10 September 2020

RE: State Planning Policy 7.3: Residential Design Codes-Volume 1 Interim Review 2020

Figure 4c – Walls with multiple articulations

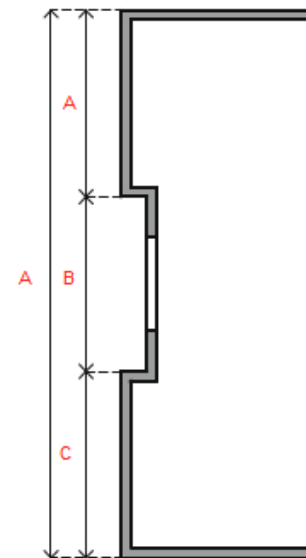
Suggest that the setback requirement for 6m high walls be reduced if minor openings or other design features are provided to break up blank walls. This will assist in mitigating blank facades on second storeys which can impose bulk and mass on adjoining properties.

<p>Recommend review of the wall heights outlined in Table 2 given that the deemed-to-comply building height is increasing to 7m it is likely that many dwellings will be designed with a wall height between 6m-7m and would be penalised with a setback requirement based on a wall height of 8m at 2.5m, almost double the current requirement for a section of wall with no major openings.</p>	
<p><i>Lot Boundary Walls</i></p> <p>Modified to:</p> <ul style="list-style-type: none"> • Remove average wall height requirement for boundary walls; • Clarification regarding concurrently proposed or simultaneously constructed boundary walls; • Clarification that 450mm x 450mm pillars and retaining walls are not considered a boundary wall for the purposes of this clause; and • Inclusion of boundary wall provisions for lots the subject of R-MD provisions. 	<p>The removal of average wall height calculations is supported. This change will simplify the assessment of boundary walls and reduce triggers for Development Applications. The visual impacts of boundary walls would still be mitigated through the maximum height and length requirements of the R-Codes, ensuring residential amenity is protected.</p> <p>The provisions relating to piers and posts is supported as it would allow smaller residential projects including patios to be exempt from requiring a Development Application.</p>	<p>With an increased number of smaller lot sizes and resultant infill development, boundary walls to more than one side is successfully provided for many designs and is a common Development Application trigger. There is generally an acceptance of walls built up to side and rear boundaries in medium to high density areas, where they meet height and length requirements.</p> <p>Suggest the inclusion of this provision within the R-Codes, which would contribute to reducing Development Applications on small lots while maintaining acceptable height and length standards for boundary walls.</p>	<p>A and C</p>
